# REGIONAL ATTENUATION POND 2A, CHERRYWOOD

## Part VIII Department Comments Response Report

Stage Approval | April 2021

Figure 2- Physical constraints

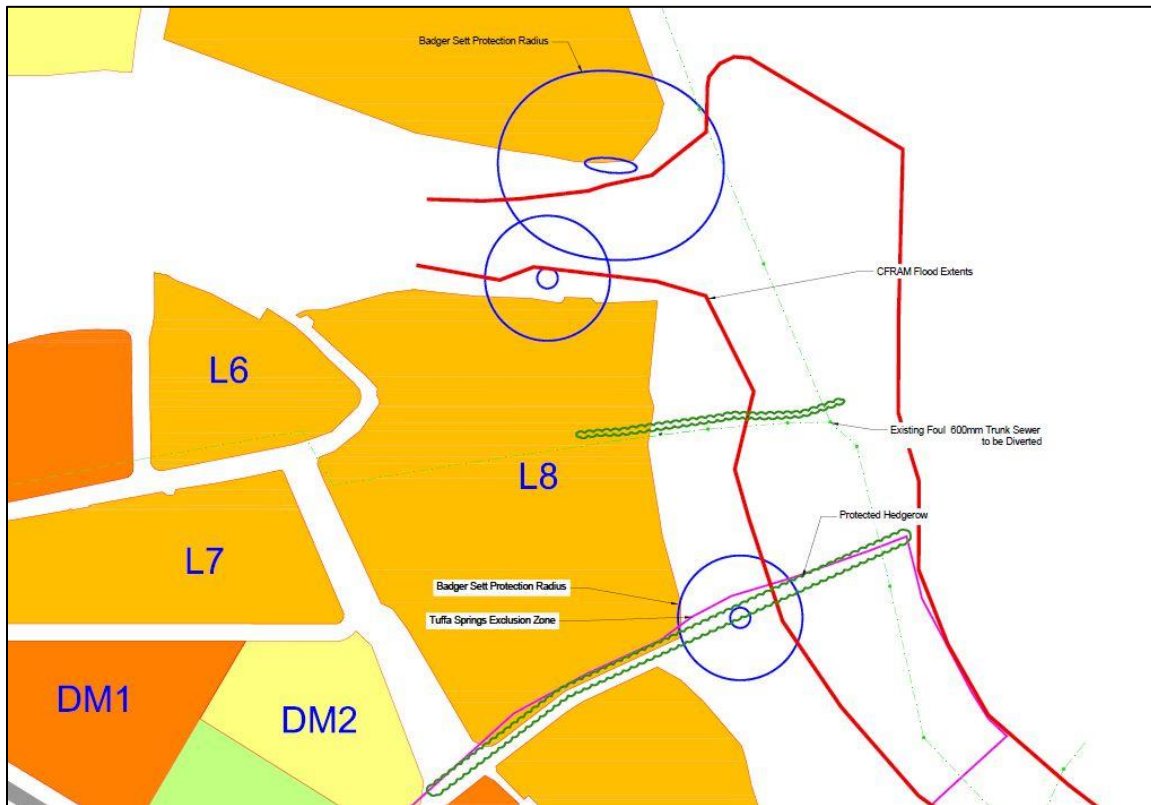
There are a number of physical constraints identified in the designated pond areas as indicated below;
